# Groundwater Application Review Summary Form

Application # G- 18837

GW Reviewer Karl Wozniak Date Review Completed: 11/14/2019

PUBLIC INTEREST REVIEW FOR GROUNDWATER APPLICATIONS

### Water-Level Trends in Nearby Wells

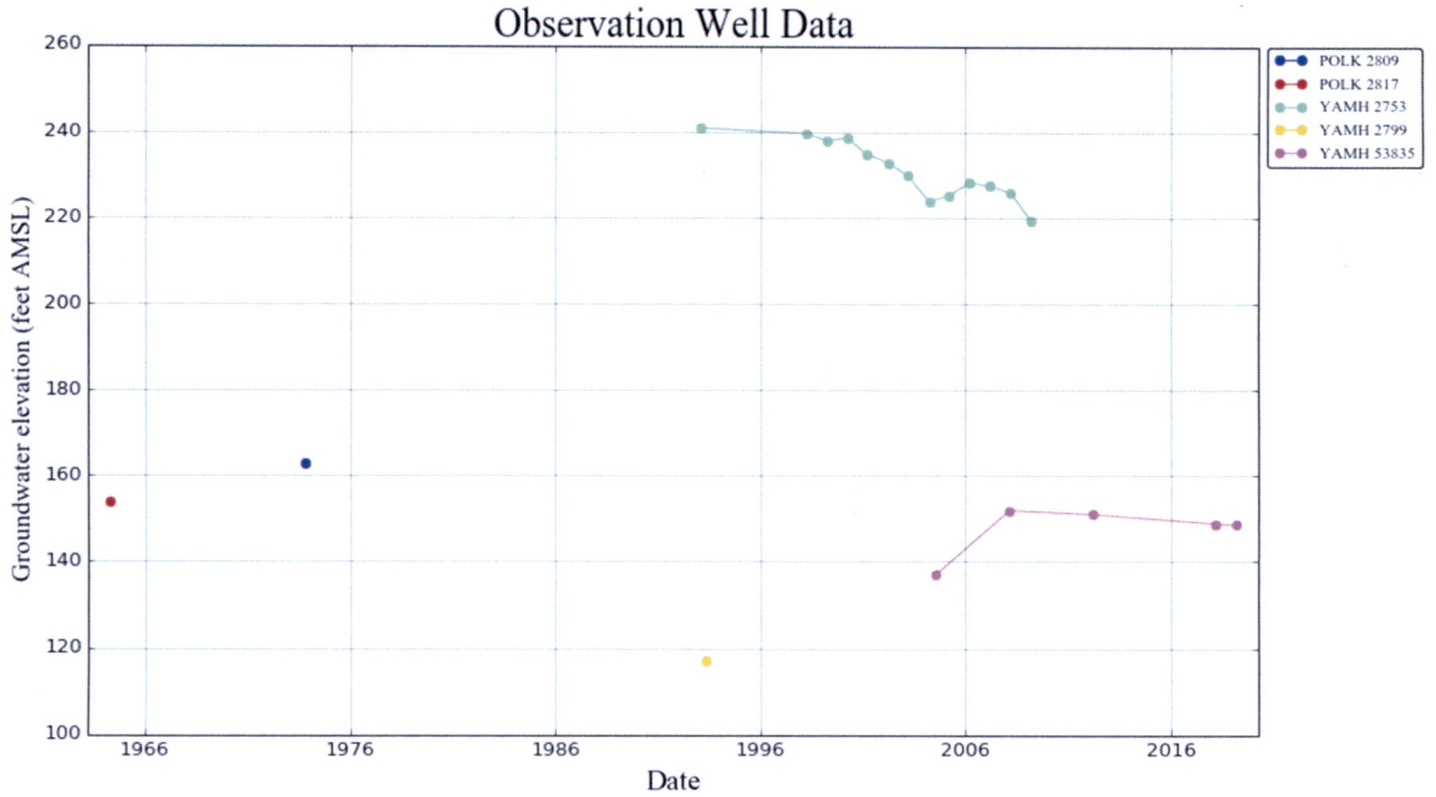
B3. **Groundwater availability remarks:** The applicant proposes to use 2 wells, 1 existing and 1 proposed, to irrigate 10 acres of land. The existing and proposed well on this application are located adjacent to Chehalem Creek approximately 1 mile northwest of the city of Newberg. The wells are underlain by about 20 feet of silt and clay (Willamette Silt Unit of Conlon and others, 2005) which is underlain by a thick sequence of older beds of consolidated Tertiary marine sediments referred herein as the low-yield bedrock aquifer system (Basement Confining Unit of Conlon and others, 2005). The wells likely produce water from fractures in the low-yield unit as most of the primary porosity has been destroyed by secondary mineralization. The low-yield unit is characterized by low permeability, low porosity, low well yield, and excessive pumping drawdowns and is generally not capable of producing sustainable yields for irrigation of high water-use crops. The OWRD well log database indicates that the median well yield in section 13 (T 3S/3W) is 18.5 gpm. Actual yields are likely to be lower since most of the reported yields are based on air tests which tend to overestimate yields in completed wells. However, some wells have reported yields of 40-100 gpm. The well report for YAMH 2799 indicates a 1-hour air test yield of 100 gpm when the drill stem was at the bottom of the hole (120 feet). Actual yield is likely to significantly lower since a 4-inch perforated PVC liner was installed upon completion of the well. Irrigation well density is low in the area but there are several dozen tax lots within a half mile of which suggests a moderate density of domestic wells. Most tax lots east of the subject wells are covered by the POU of the City of Newberg’s municipal water right under permit G-17583 (not shown on the included map). A few observation wells in the area (see hydrograph below) show mixed signals regarding the stability of water levels over time. Because of the nature of the aquifer system, potential water-supply problems from the proposed use are likely to be relatively local but it is difficult to predict potential impacts in a fracture porosity system. Also, tax lot maps suggest that a number of domestic wells occur within 1000 feet of the subject wells. These facts indicate that it would be prudent to require water-level and water-use monitoring conditions if a permit is issued by the Department.
